**Monks Orchard Residents'  
Association  
Planning**

Reference	21/06038/FUL
Application Received	Fri 03 Dec 2021
Application Validated	Sat 04 Dec 2021
Address	176 - 178 Orchard Way Croydon CR0 7NN
Proposal	Demolition of existing dwellings, erection of three pairs of two storey 3-bed semi-detached dwellings with roof accommodation and one pair of two storey 2-bed semi-detached dwellings with car parking, formation of accesses onto Sloane Walk together with a new pavement, and provision of cycle, refuse and recycling stores and soft landscaping
Status	Awaiting decision.
Consultation Expiry:	Sat 01 Jan 2022
Decision Deadline:	Tue 25 May 2021
Case Officer:	Ms. Victoria Bates

Please accept this letter as a formal objection to **Application Ref: 21/06038/FUL** for the Demolition of the existing dwellings, erection of three pairs of two storey 3-bed semi-detached dwellings with roof accommodation and one pair of two storey 2-bed semi-detached dwellings with car parking, formation of accesses onto Sloane Walk together with a new pavement, and provision of cycle, refuse and recycling stores and soft landscaping.

## 1 Comparison with previous proposal

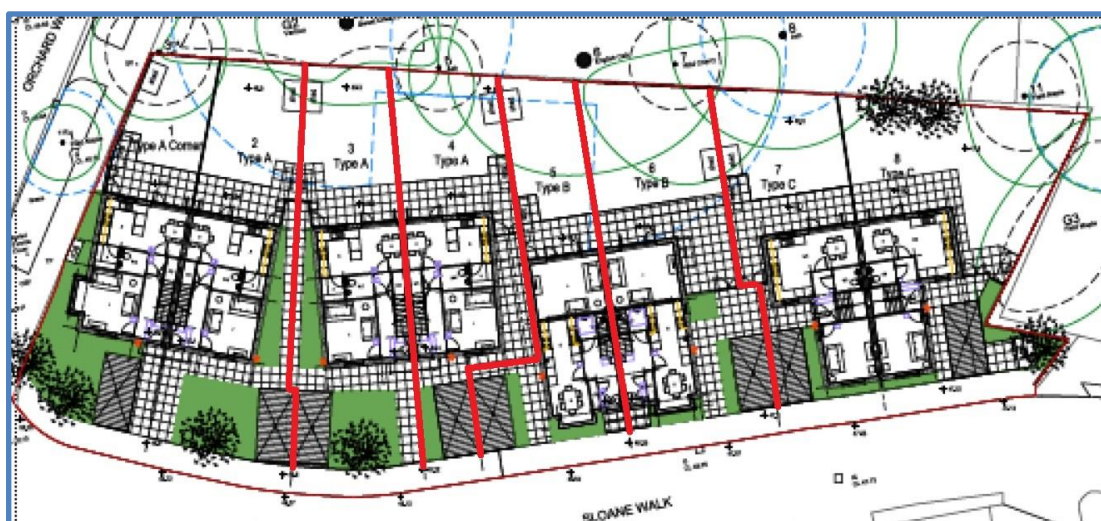
- 1.1 The new proposal is not significantly different from the previous refused proposal which is pending an appeal.
- 1.2 The building footprints seem unchanged.
- 1.3 The accommodation capacities have increased slightly, although the Bed Spaces are not actually detailed. The accommodation is only assessed by looking at the plans.

- 2.1.3 The dwelling footprints remain the same as the previous refused proposal. The only changes are Parking Bay rearrangements and reduction from 12 to 8.

- 2.1.4 The Curtilages and Boundaries have not changed from the original which were modified simply to accommodate the Parking Bays, significantly for Unit 5 on what would normally be considered Unit 4's forecourt. The curtilage and boundary is bent to fit! Thus **Unit 4's Front Lounge window view will be Unit 5's Parked vehicle!** Not very comforting for the future occupants of **Unit 4** for the life of the development. This is an obvious indication of failure to follow the presumed normal curtilages in order to squeeze the parking provision within the limitations of the site which is evidence of the development exceeding the capacity of the Site.

**Google Image showing 800m line of sight radius from the proposed does not include any Tram/Train Station or District Centre redevelopment site.**

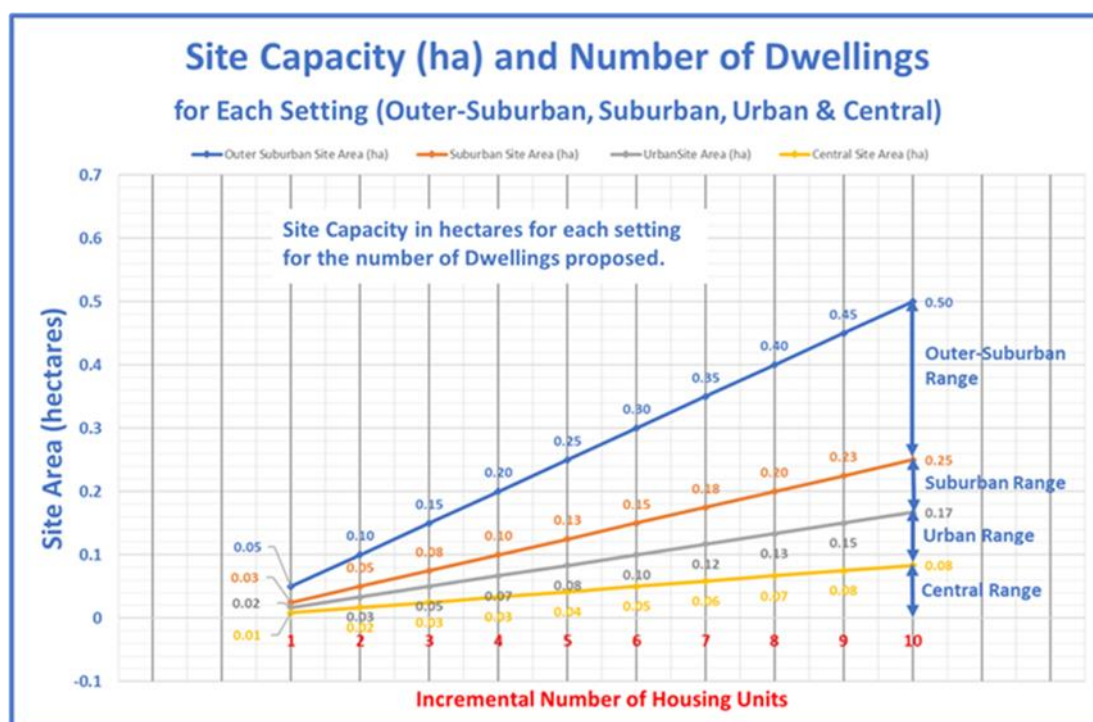
- 3.2.2 The implication of **Para 4.2.4** is that **“Incremental Intensification”** is **“inappropriate”** at **PTAL levels** below **3** and at distances greater than **800m** from either **train/tram Stations** or **District Centres**.

- 3.2.3 The locality of the proposed development is **Outer-Suburban** or **Suburban<sup>3</sup>**, and **176 Orchard Way** is at **PTAL Zero** and **178 Orchard Way** is at **PTAL 1b** (TfL WebCAT). Thus, below **PTAL 3**. The location is also greater than **800m** from any **tram** or **train Station**, the nearest of which is **Eden Park Rail Station** (greater than 800m from the site) and greater than 800m from a District Centre. The Shirley Centre is defined as a Local Centre in the Croydon Local Plan which is NOT a District Centre.

**Design Code Housing Density for 176-178 Orchard Way compared to Local Average Assessments using the National Model Design Code.**

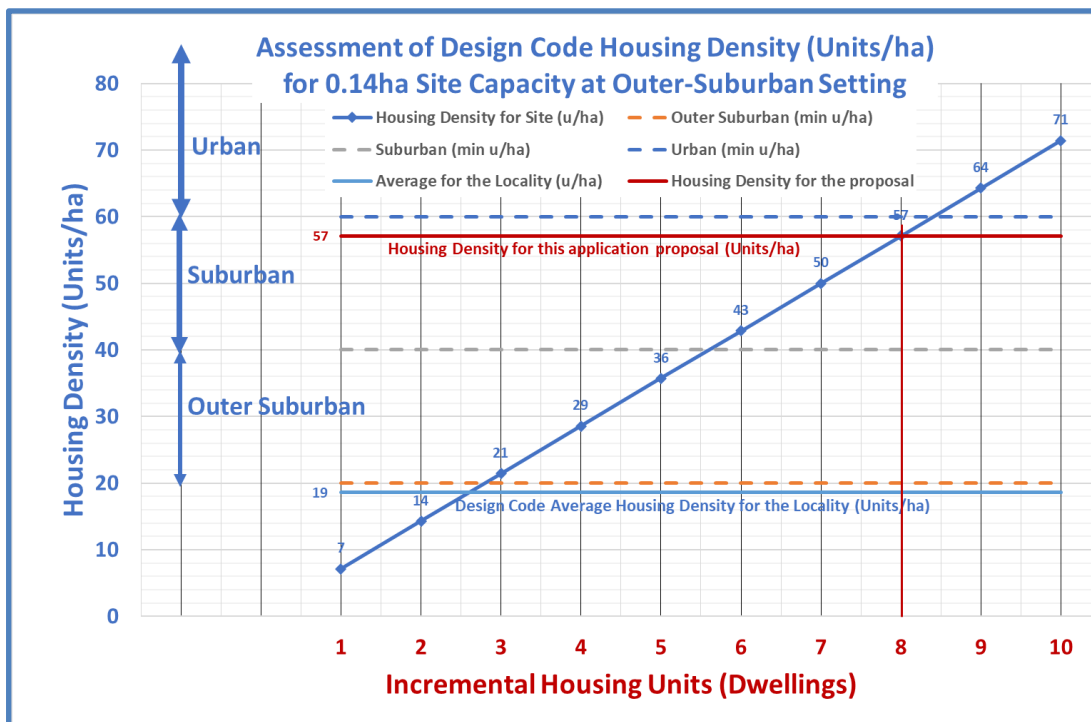
- 3.4.6 Proposal's Site Capacity of 0.14ha at Outer- Suburban Setting.

- 3.4.7 As shown above, the housing densities for the areas listed, where data is available, are all **Less than or within** the **LUHC National Model Design Code Settings** for **Outer Suburban**. Based on this assessment, the proposed development exceeds the **Average Housing Design Code Density** of **18.63 Units/ha** (Outer Suburban Setting) to a value of **57.14 Units/ha** (Suburban Setting) an increase of **206.79%** which is **NOT** considered a **proportionate** or a reasonable interpretation of **“Moderate”** or **“Gentle”** increase in **“Growth”** in a locality which by definition is **inappropriate** for **“incremental Intensification”** (London Plan Policy H2 para 4.2.4).

**Graphical illustration of required PTAL for the proposal's Residential Density whether measured in hr/ha or bedspaces/ha when the Site PTAL is ≈1.**

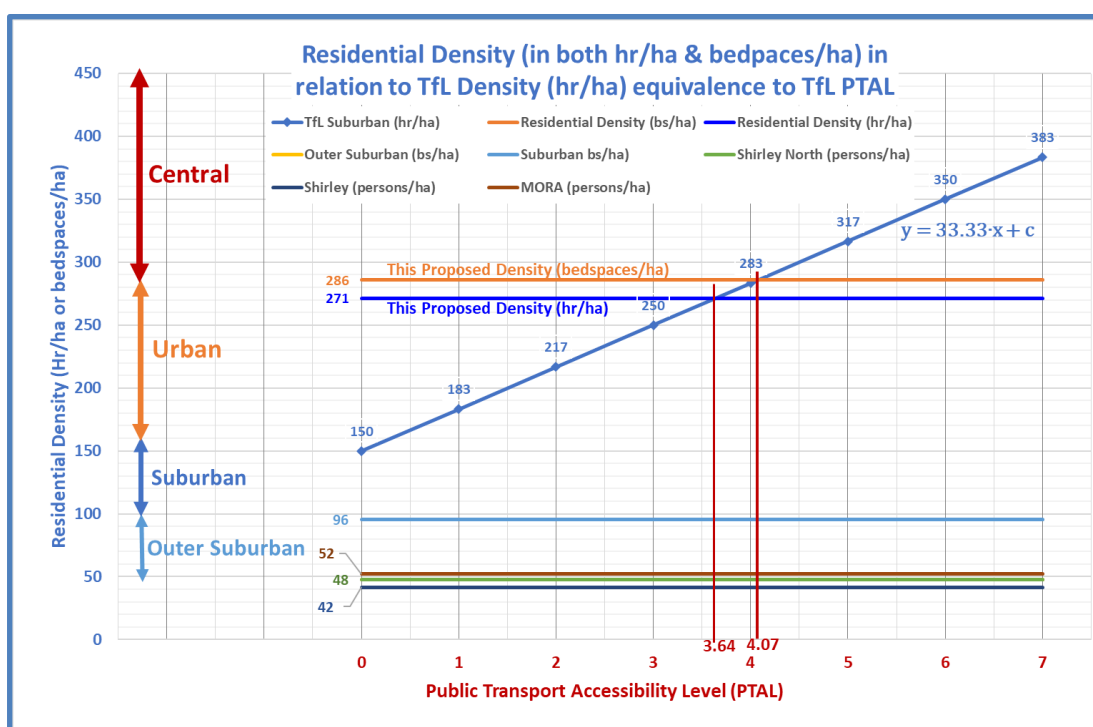
Therefore, for a Residential Density of 285.71 bedspaces per hectare the PTAL required would be given by:

$$285.71 = ((350 - 150) / 6) \cdot x + 150 \text{ therefore } x = \text{PTAL} = 4.072$$

And for a Residential Density of 271.43 hr/ha, the PTAL required would be given by:

$$271.43 = ((350 - 150) / 6) \cdot x + 150 \text{ therefore PTAL} = 3.643$$

- 3.5.4 This analysis clearly indicates the assessment of **Residential Density** of the proposal exceeds the available **Public Transport Accessibility Level (PTAL)** required for the proposal which would remain so at least up to 2031, which is clearly unsustainable.
- 3.5.5 The overall assessment is that this proposal is a significant over development of the **Site Capacity** for the Design Code "**Setting**" of "**Outer Suburban**" both in terms of Housing and Residential Densities as assess of the **NPPF National Model Design Code and Guidance**. If the Case Officer disagrees with this analysis based upon the NPPF guidance, we would respectfully request that a detailed justification is provided in the recommendation Report for determination to the Delegate or Planning Committee. We are convinced that the proposal significantly exceeds the available **Site capacity**

### 3.6 Application Floor Area Ratio (FAR) Design Code.

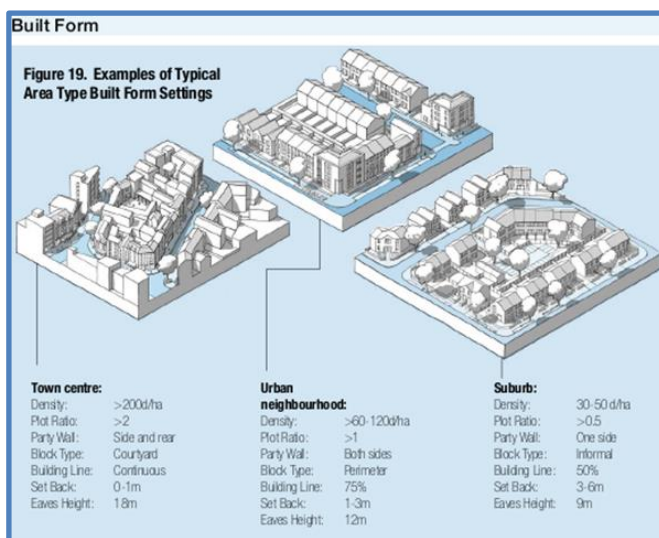
3.6.1 The Floor Area Ratio is determined by **Gross Internal Area ÷ Site Area** (both in the same units of measure. The recommendation for a Suburban Setting is that the Floor Ratio Design Code should be **LESS THAN 0.5**.

3.6.2 Therefore, for this application, the floor Area Ratio is **920.88/1400** in **m<sup>2</sup>** which is 0.66 i.e., greater than 0.5 by 0.16 i.e., a **32%** increase above the maximum **Design Code** recommended. This is another indication of exceeding the available '**Site Capacity**'.
